ADDENDUM NO. 30 - Contract Drawing C.1

**CONTRACT 876-HP
GEOMEMBRANE CAPPING AND
GAS COLLECTION SYSTEM
PELHAM BAY LANDFILL REMEDIATION
BOROUGH OF THE BRONX
NEW YORK**

Bid Form - Contract No. 876-HP - Revised 5/25/94

SCALE:	DWG. NO.:	SHEET NO.:
AS NOTED	C.13R1	14
DATE:	OF:	OF:
MAY 18, 1994	C.19	28

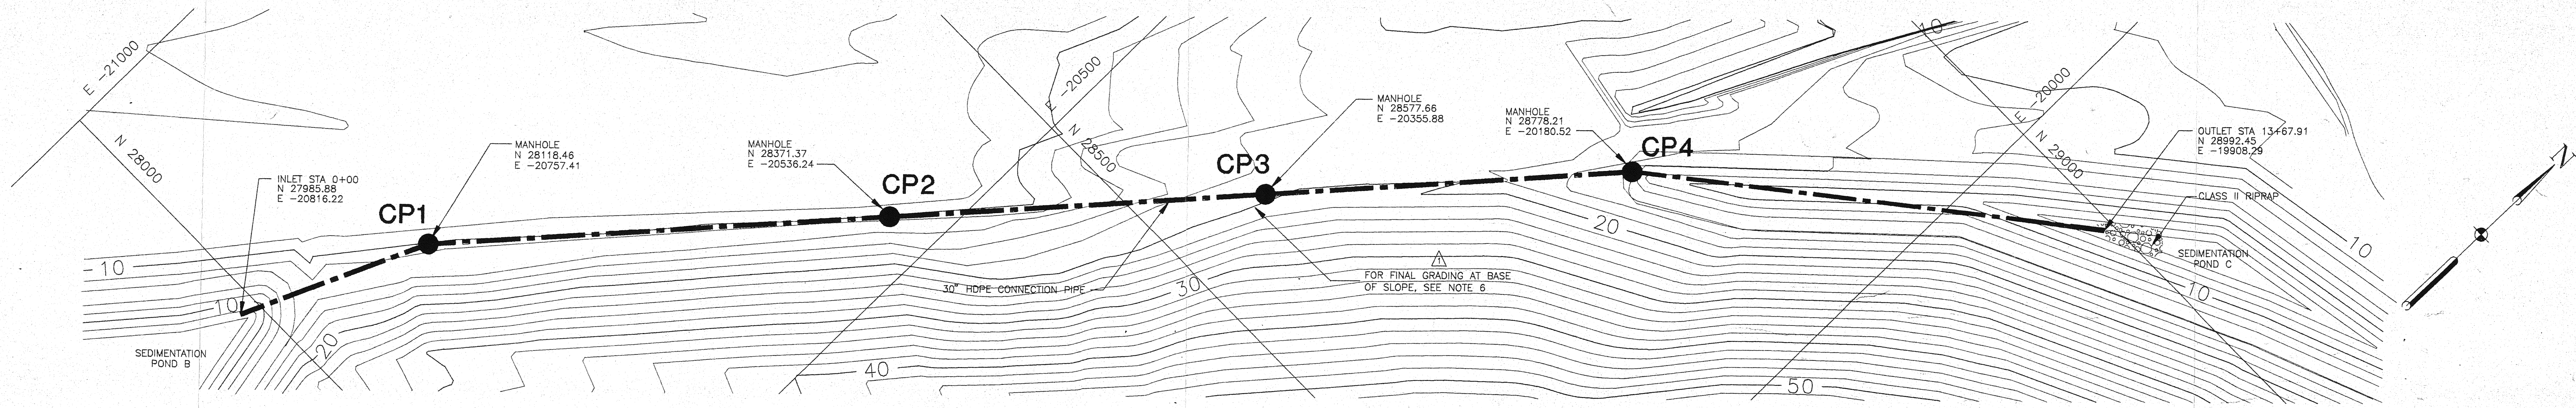
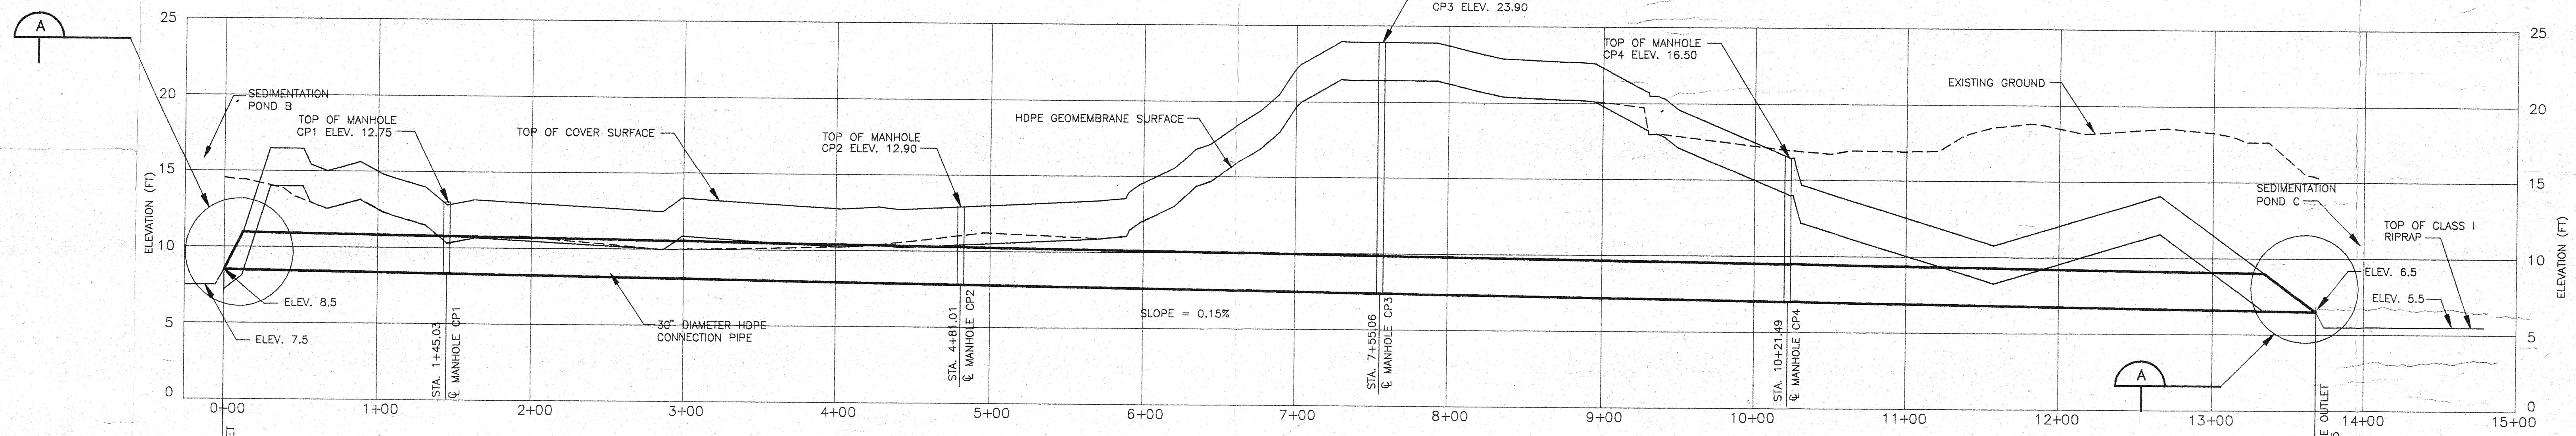
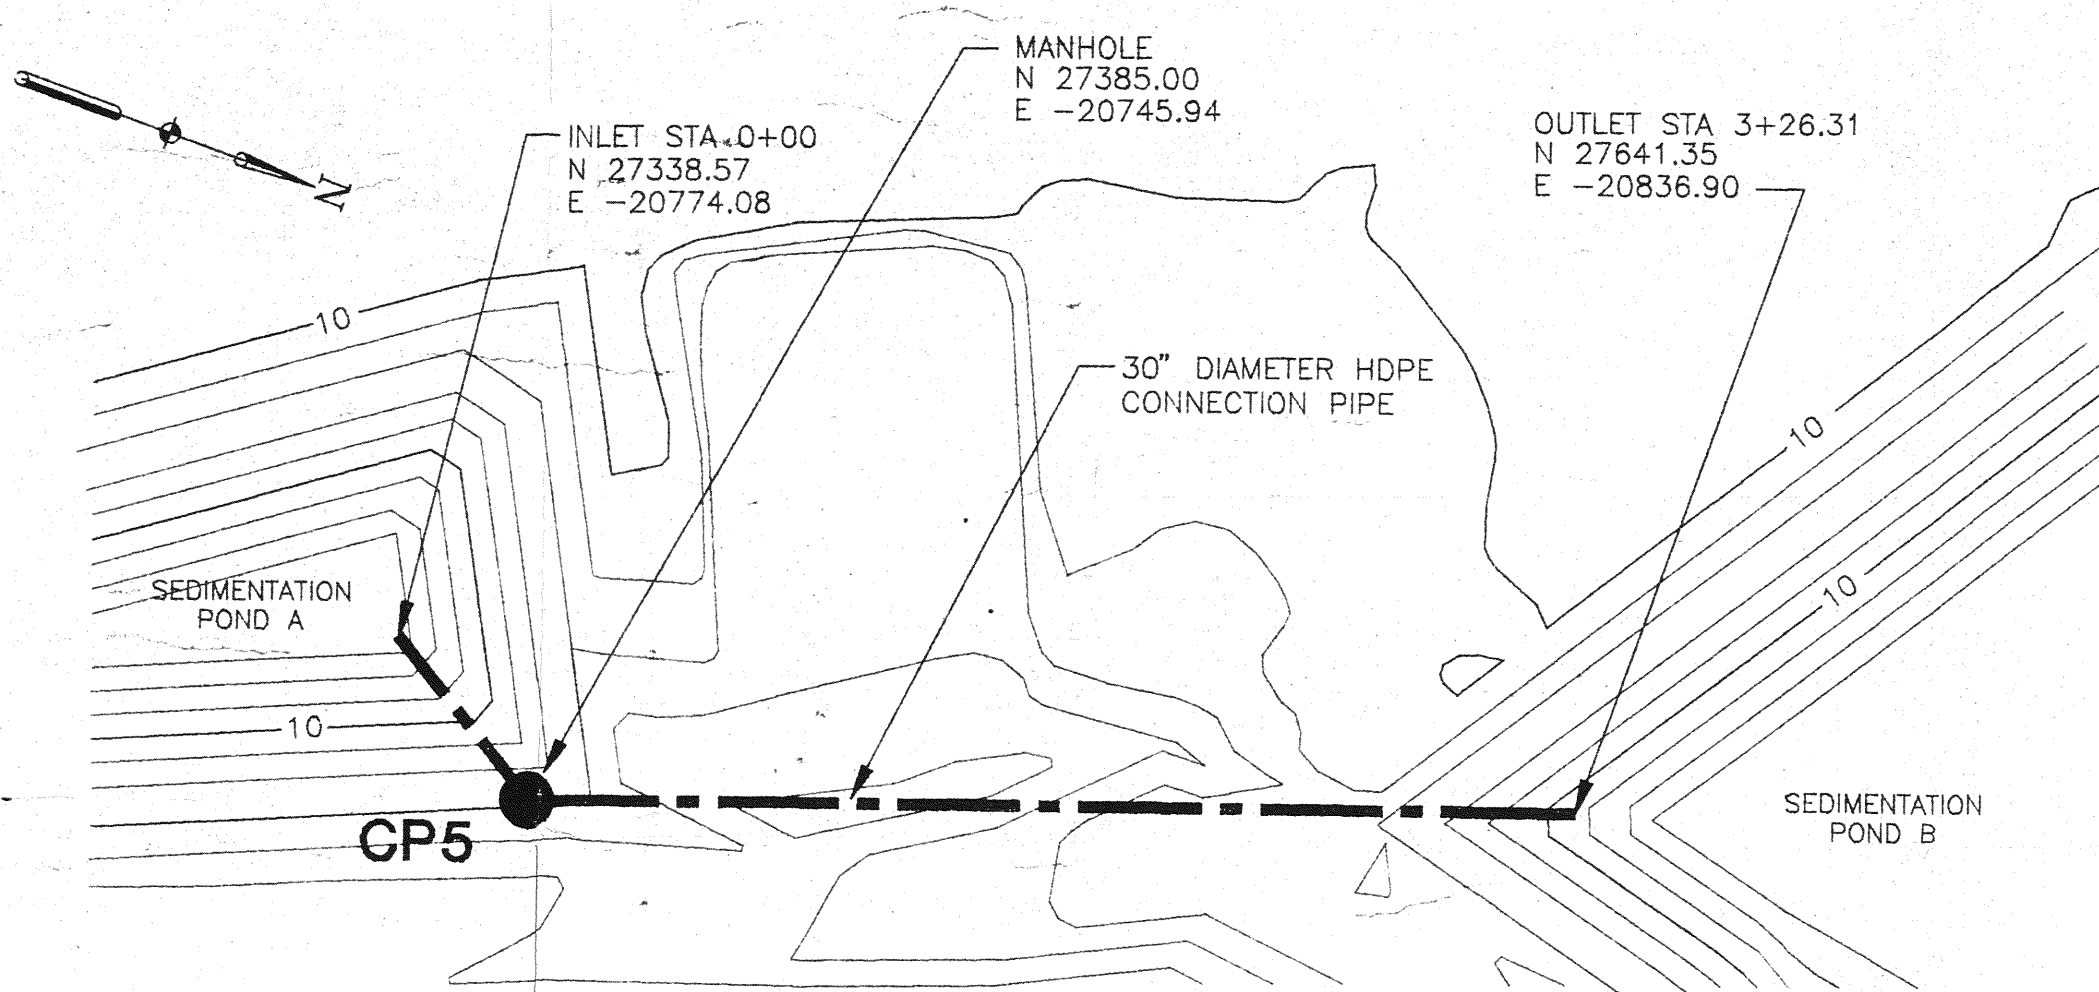
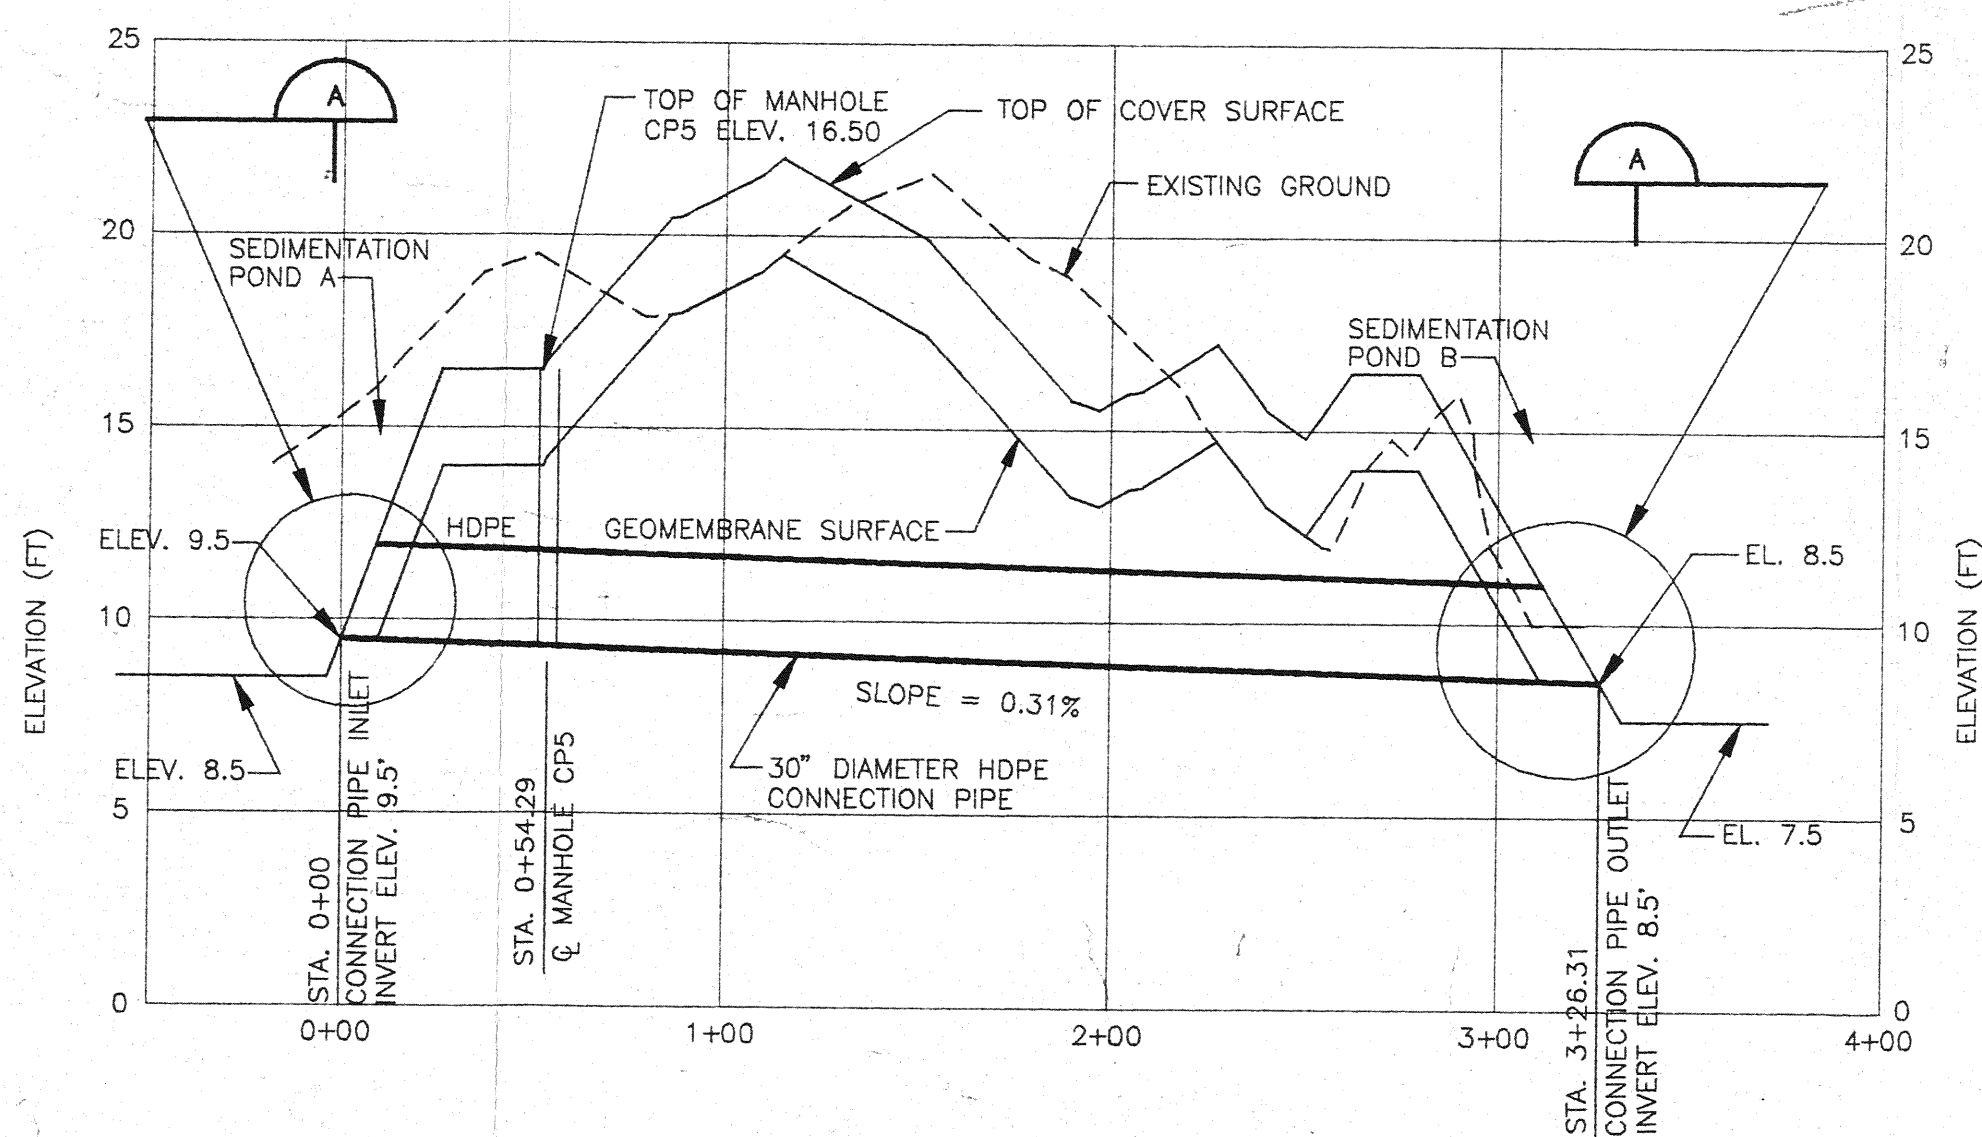
1. Replace Contract Drawing C.13 with revised version (Drawing C.13R1), attached at the end of this package. Revisions made to this Drawing are described below:
 - A. "EXISTING CURTAIN DRAIN SEE TYPICAL SECTION D THIS SHEET" and "EXISTING GRAVEL DRAIN SEE TYPICAL SECTION E THIS SHEET" were added to the "SEDIMENTATION POND B - PLAN".
 - B. EXISTING CURTAIN DRAIN - SECTION D and EXISTING GRAVEL DRAIN - SECTION E were added to clarify the existing drains at the location of Sedimentation Pond B.

Refer to sheet 15/28, SEDIMENTATION POND B TO C CONNECTION PIPE - PROFILE: There is a conflict, in grade, between the top of the 30"φ HDPE connection pipe and the proposed geomembrane between Sta. 1+40± to 3+00±, Sta. 11+20± to 11+95± and in the vicinity of Sta. 4+00±. How shall this conflict be resolved?

GAS COLLECTION AND FLARING SYSTEM PLAN

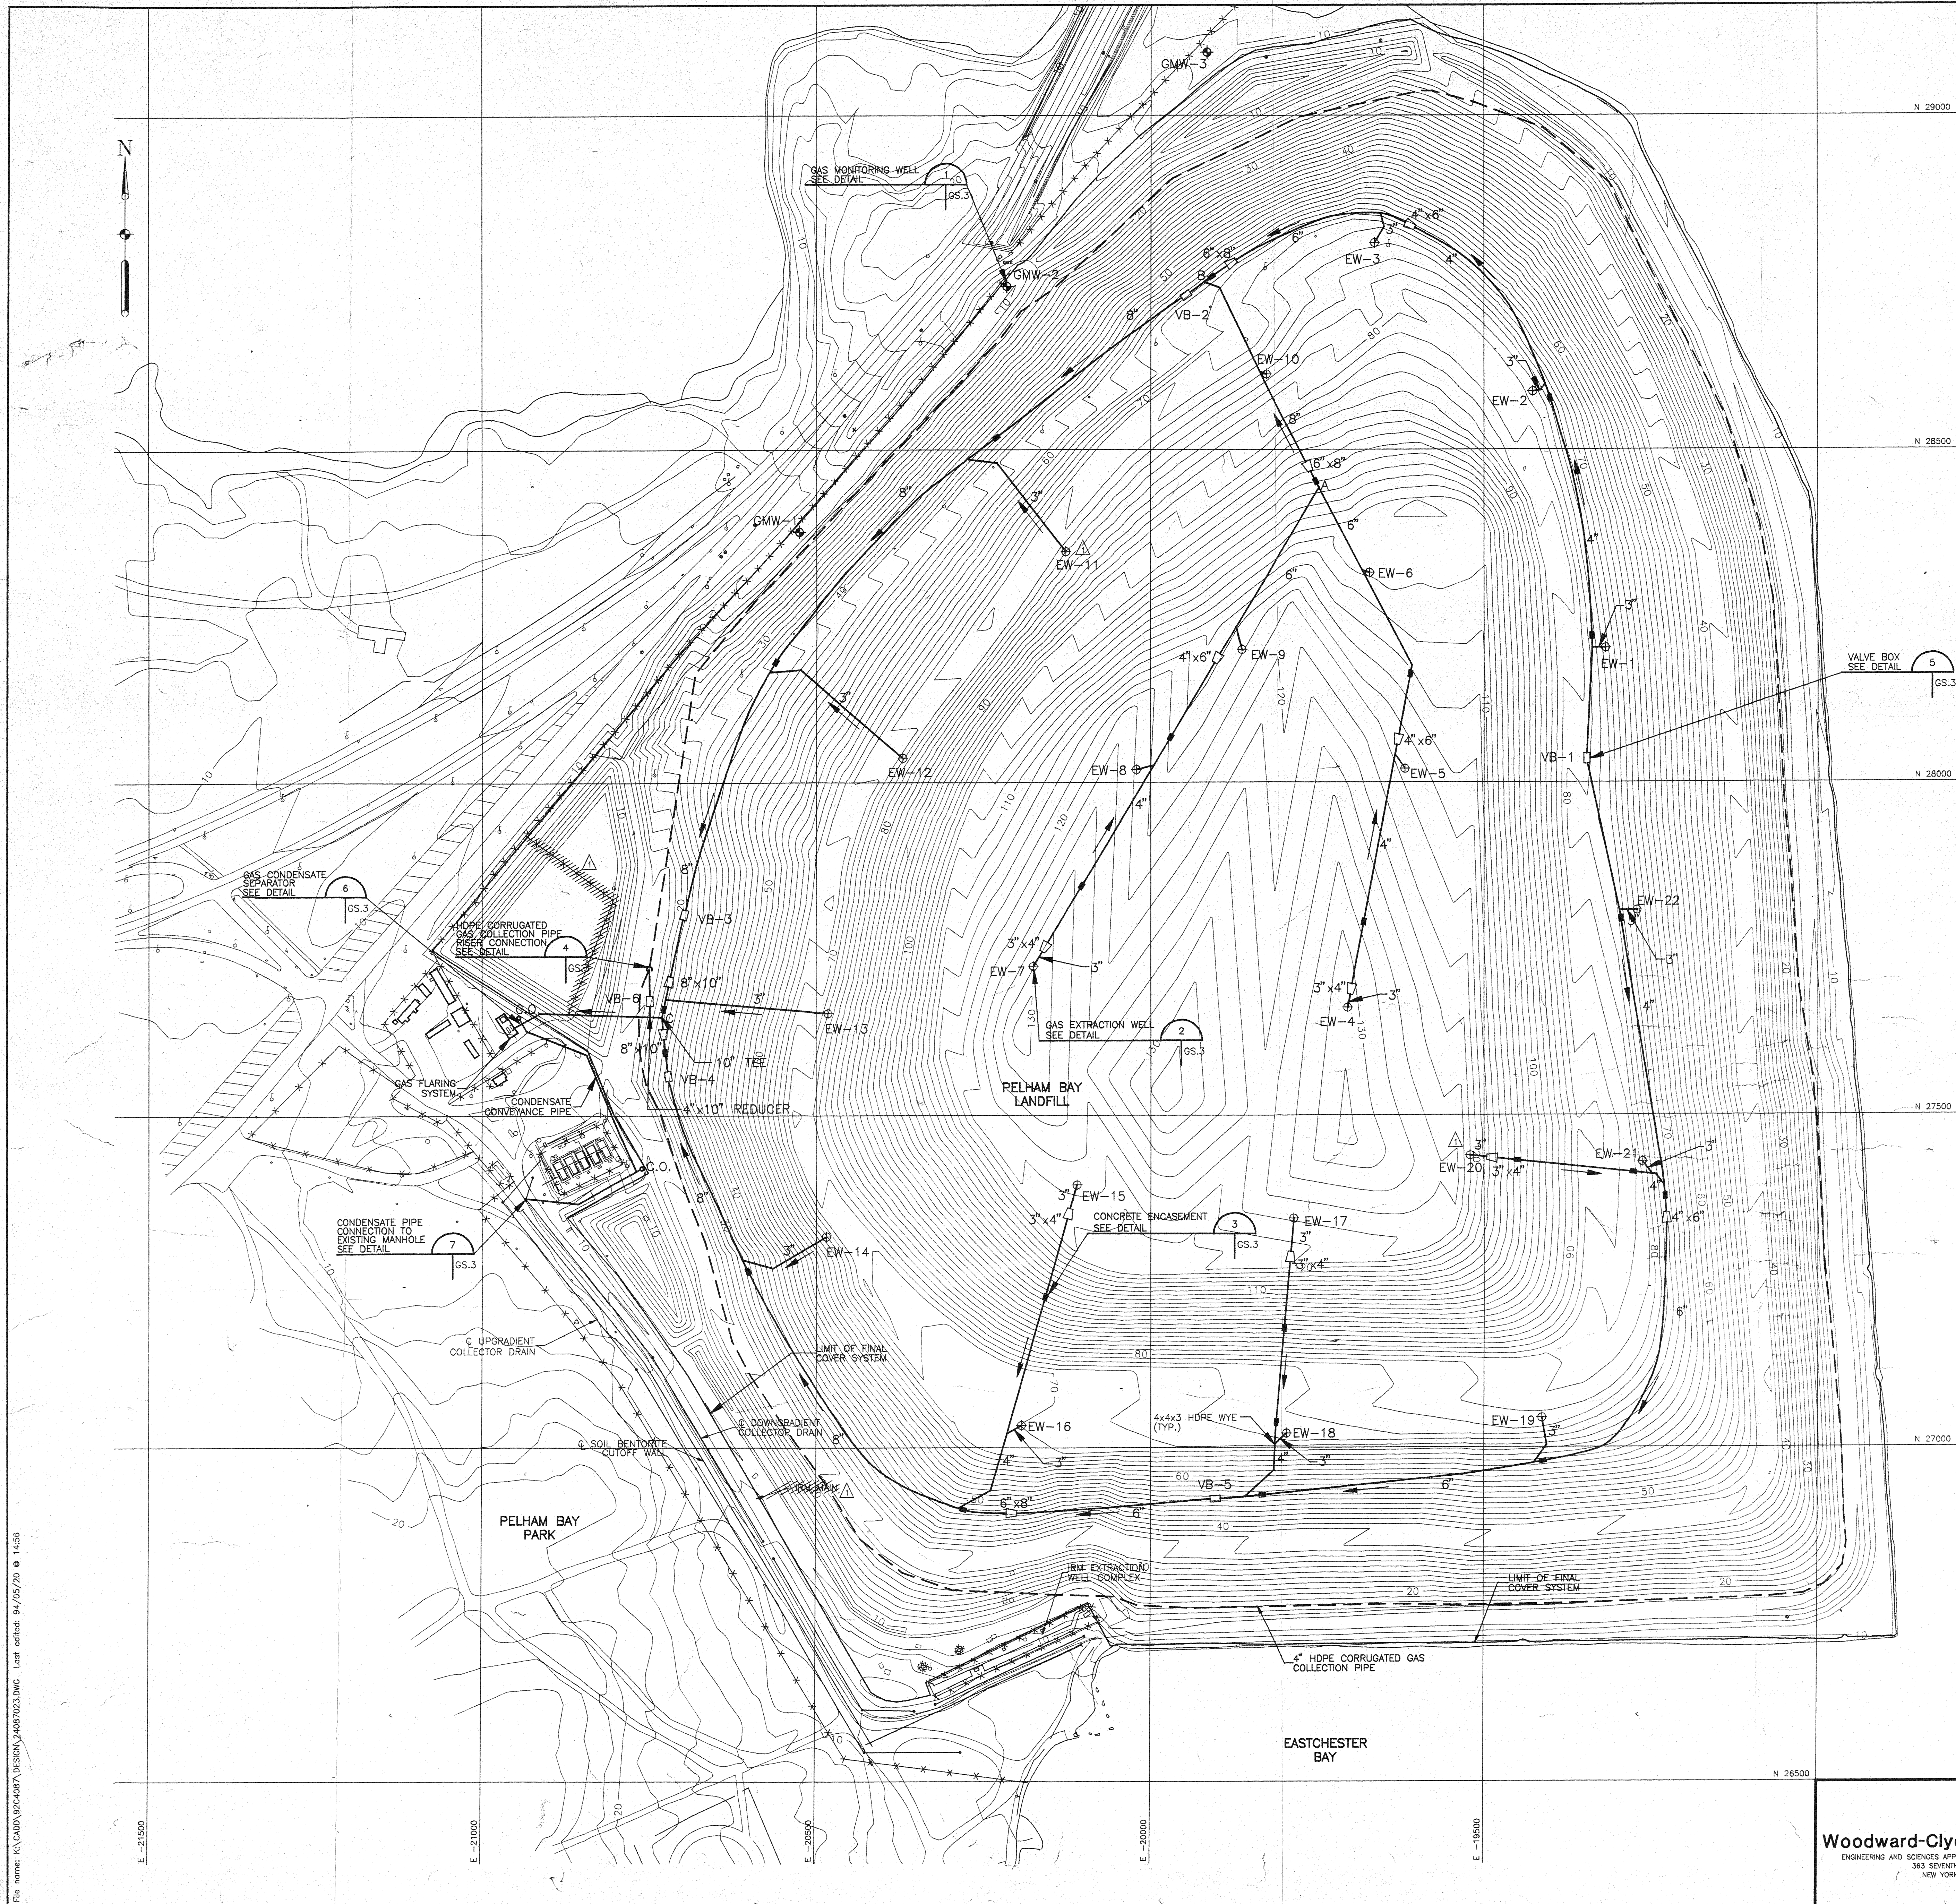
1. Replace Contract Drawing GS.1 with revised version (Drawing GS.1R1), attached at the end of this package. Revisions made to this Drawing are described below:
 - A. Delete fence shown within Sedimentation Pond B.
 - B. Delete "IRM MAIN" located adjacent to the intersection of grid E-20500 and N27000.
 - C. Modify location of extraction wells EW-11 and EW-20.
 - D. Change northing and easting coordinates for extraction wells EW-11 and EW-20 in Gas Extraction Well Schedule.
 - E. Adjust Well Depth numbers in Gas Extraction Well Schedule.
 - F. Show 2-ft contour lines.
 - G. Add Note 9.

Refer to sheets 21 and 23/28: The depth and length dimensions shown on Drawing GS.1 (in the table on right side of drawing) do not agree with those on the gas extraction well detail on Drawing GS.3. Please clarify.

Refer to Addendum No. 41 (which revised Contract Drawing GS.1) paragraph 1E. The revised Gas Extraction Well Detail is presented in Addendum No. 42 (page 66 of Addenda to Contract Documents Volume No. 3).
